Central Barangaroo

DPHI and GANSW Response

Prepared for INSW

Issued 31 May 2023

Figure 59 of the Rts report - Illustrative view from Hickson Park looking towards the Sydney Harbour

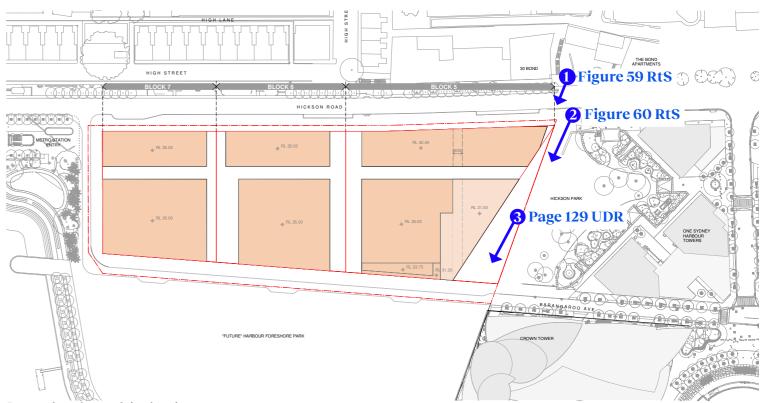
5. Hickson Park Views - Proposed Envelope

1. Figure 59 in the Rts report (and below) illustrate the ground level view of the Hickson Park looking towards the Sydney Harbour from the locations as

5. Hickson Road interface

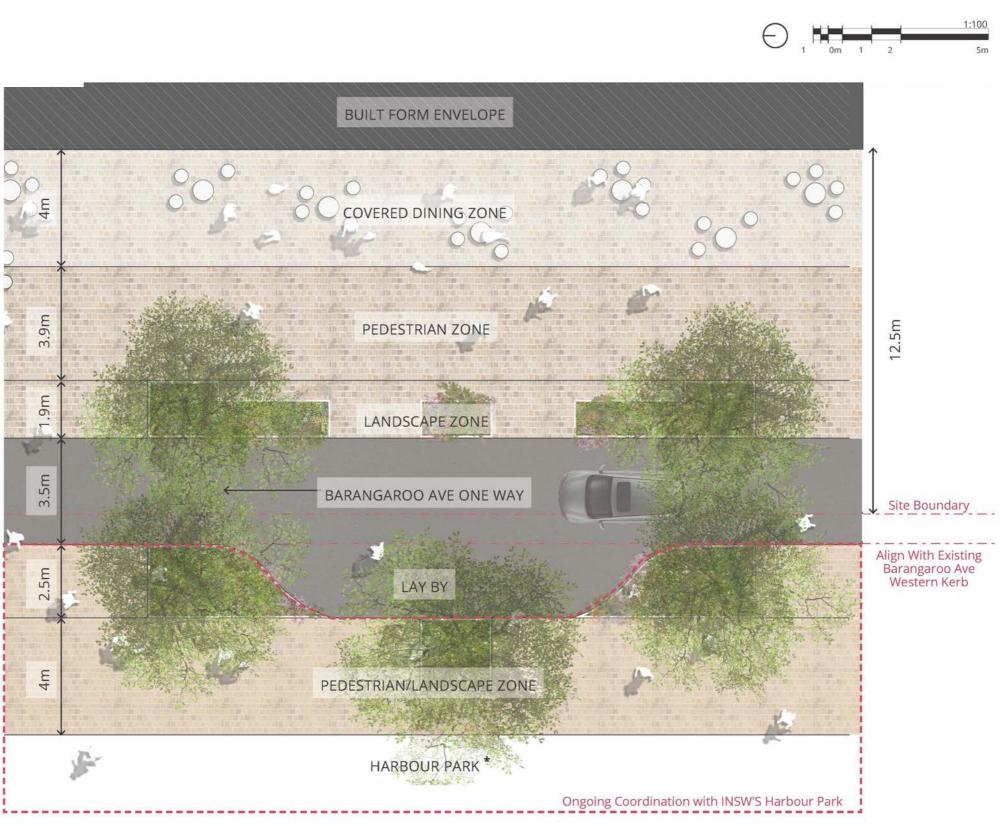
- 1. Promote the use of awnings along Hickson Road where appropriate, supporting retail, building envelopes, and/or other activation.
- 2. Activate the Hickson Road frontage with building entrances and retail evenly distributed along its length, where possible.
- 3. Ensure considered design and location of loading and service access to avoid the Hickson Road interface presenting as 'back-of-house'.
- 4. Building design fronting Hickson Road are to consider the heritage aspect of the adjoining Millers Point and Dawes Point heritage precinct.

- 1. Opportunity for significant street tree planting along the western side of Hickson Road; greening and softening the hard edge between High Street, the exposed cliff-face and Barangaroo Central
- 2. Consider materiality to ensure a cohesive public domain treatment to provide a consistent visual language, encouraging pedestrians to move through to the plaza spaces
- Promote pedestrian movement and active transport along 3. Hickson Road
- 4. Provide dedicated bi-directional cycleway along the eastern side of the street

6. Barangaroo Avenue

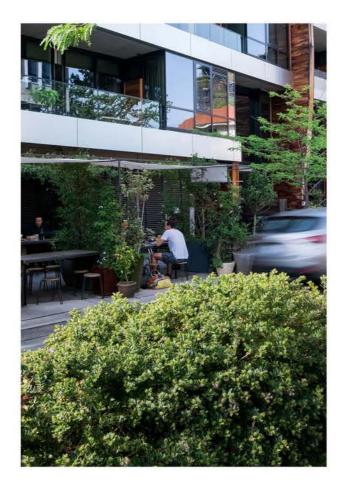
- Supports protected pedestrian movement
- Supports protected outdoor dining connected to Harbour Park and connection to water and landscape
- Provides continuous active frontages for passive surveillance to the public space(s)
- Consider the west orientation in the design of the _ buildings to ensure user comfort

- Allow the harbour park to visually flow into the shared space, not creating a defining edge
 Large trees to frame views towards Headland
- Reserve and provide shade from west facing aspect
- Consider the location of retail and other built form to not block connection between the park and plaza spaces
- Encourage the public domain to flow seamlessly between Harbour Park and Barangaroo Central
 Consider materiality to ensure a cohesive public
- domain treatment
- Encourage outdoor dining that takes advantage of the west facing aspect
- Assist with wind amelioration into public spaces with a west facing aperture
- Barangaroo Avenue to extend the full length of the site
- Barangaroo Avenue to be designed as a slow _ traffic zone, prioritising pedestrian east-west movements
